Item: PC#24-019 - 750 W. Northwest Hwy & 660 N. Ridge Ave. -
Arlington Ridge Center Sign -
PUD Amendment, Special Use Permit, Amendment to
Comprehensive Plan, Rezoning with Variation

VILLAGE OF ARLINGTON HEIGHTS STAFF DEVELOPMENT COMMITTEE REPORT

Project Number: PC 24-019
Project Title: Arlington Ridge Center - Sign
Location: 660 N. Ridge Ave & 750 W. Northwest Highway
PIN: Multiple PINs (See **Exhibit A**)

AHPD ADDITION
TO LEGACY/ARC
PUD & ELECTRIC
SIGN PLANS

MASTER PLAN PUD EXHIBIT

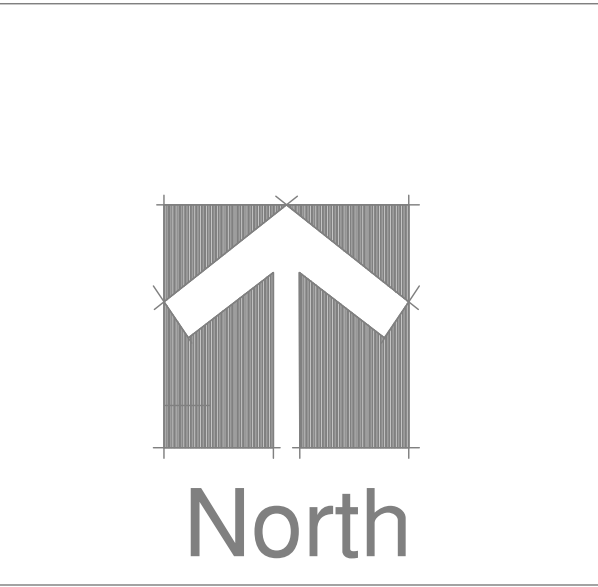
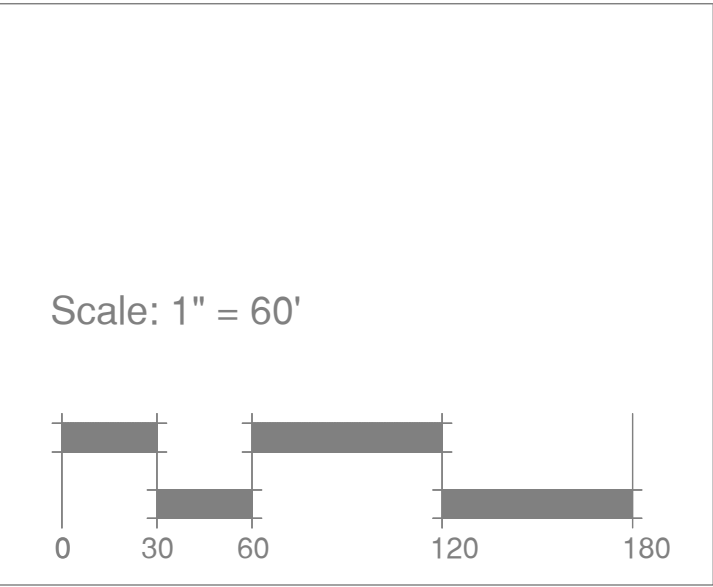
11. On the Master Plan PUD Exhibit (sheet 10 of "PUD_PLAN_SET_ELECTRIC SIGN_10.8.24"), please revised the plan to show an overall view of the amended PUD to include 750 W. Northwest Highway into the overall plan. The law office building should be removed and the proposed signage should be shown to match Design Commission plans. This overall PUD should show level of detail for utilities, sidewalk, landscaping, adjacent rights-of-way, and land use for the whole site, including this addition.

11. On the Master Plan PUD Exhibit (sheet 10 of “PUD_PLAN_SET_ELECTRIC_SIGN_10.8.24”), please revised the plan to show an overall view of the amended PUD to include 750 W. Northwest Highway into the overall plan. The law office building should be removed and the proposed signage should be shown to match Design Commission plans. This overall PUD should show level of detail for utilities, sidewalk, landscaping, adjacent rights-of-way, and land use for the whole site, including this addition. **Response: Revised per the above.**
